P 520004-A

**ON-SITE SEWAGE DISPOSAL SYSTEM
HOWARD COUNTY HEALTH DEPARTMENT
BUREAU OF ENVIRONMENTAL HEALTH
3525-H ELLICOTT MILLS DRIVE, ELLICOTT CITY, MD 21043**

SUBDIVISION: Riggs Meadow LOT NUMBER: 12

Re: Proposed Pool Location
Riggs Meadow Lot 12
14618 Riggs Meadow Drive

Approved Septic System Plan Howard County Health Department

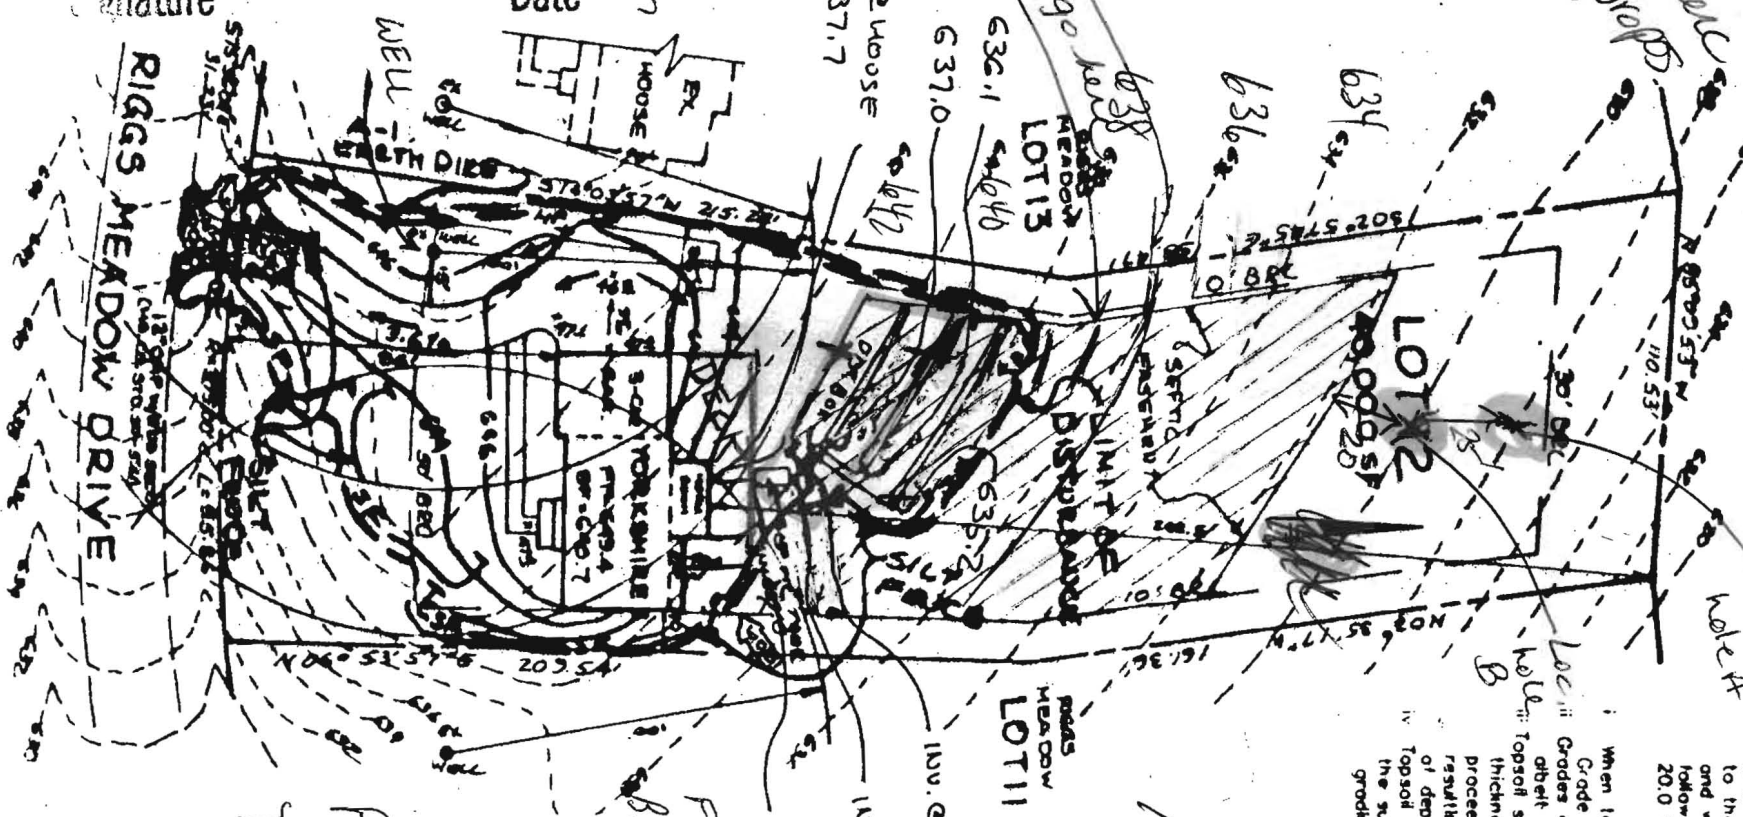
Ex. Current location if
last trench
in 1st system

Replacement would
trench

12/4/03
prop

Note: If galled due to Rejuvenal
@ 7 1/2' above upwell 25 feet.
Note: B marginal, R begins @
8', Rejuvenal @ 12 1/2', however not enough
Riggs Meadow 3m x 5m. Approx.
PRES. PARCEL 'A' location

PLAN BY
TSA Group
6/9/98
No Room for 3rd
sys

Review of your most recent proposed pool location has been approved and noted in our file. However, this approval is contingent upon replacing the second highest trench with a new trench below the existing fourth trench. The permit fee for a septic alteration, which is accommodating the pool location, is \$180.00. Once our office has received the fee, we will issue the septic permit first, then sign the pool permit after installation.

Keep in mind there is not much room for error due to shallow rock in the northern section of your backyard. The regulations require a 20' setback from the water's edge of the pool to the closest trench and a 10' separation distance from the pool to the septic tank. A sanitarian will be assigned to inspect the septic installation to ensure the regulations are met.
